## SECTION 009113 – ADDENDUM TWO

- A. Project Identification: Laurel School District Mason Elementary School Restrooms Addition Project.
- B. Owner: Laurel School District, 303 W. 8<sup>th</sup> Street, Laurel, MS 39441.
- C. Architect: Dale | Bailey, an Association, One Jackson Place, Suite 250, 188 E. Capitol Street, Jackson, MS 39201-2100
- D. Architect Project Number: 23003
- E. Date of Addendum Two: 10 July 2023

Addendum Two  
Laurel School District  
Mason Elementary School  
Restrooms Addition Project  
Laurel, Mississippi

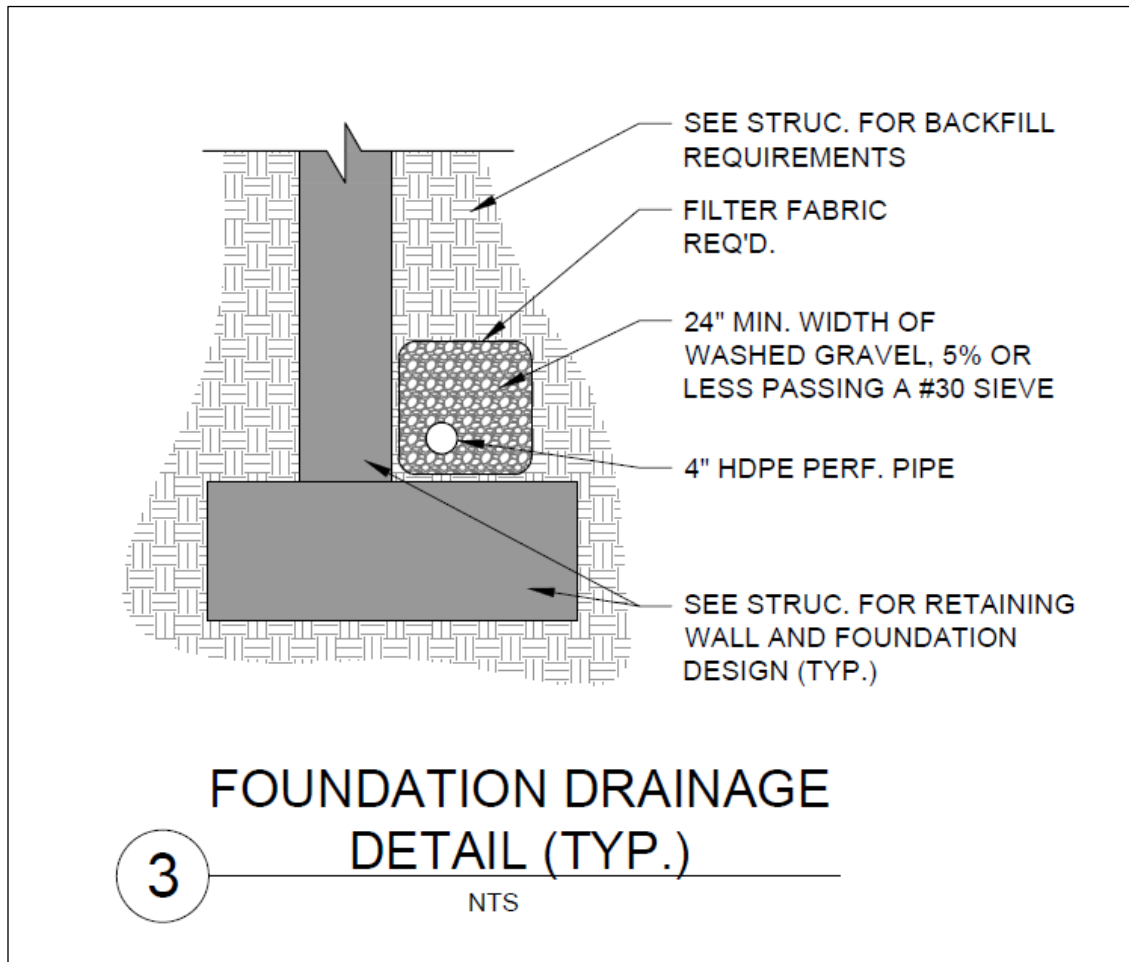
- A. Question: Can you provide clarification of the French drain that is being installed on top of the footing against the retaining wall footing? I cannot any other details on it other than on structural detail for footing. Please let me know.

Answer: Contractor should install foundation drain as per this detail. Use 4" PVC to hard pipe through foundation and tie into existing inlet between building addition and existing roadway.
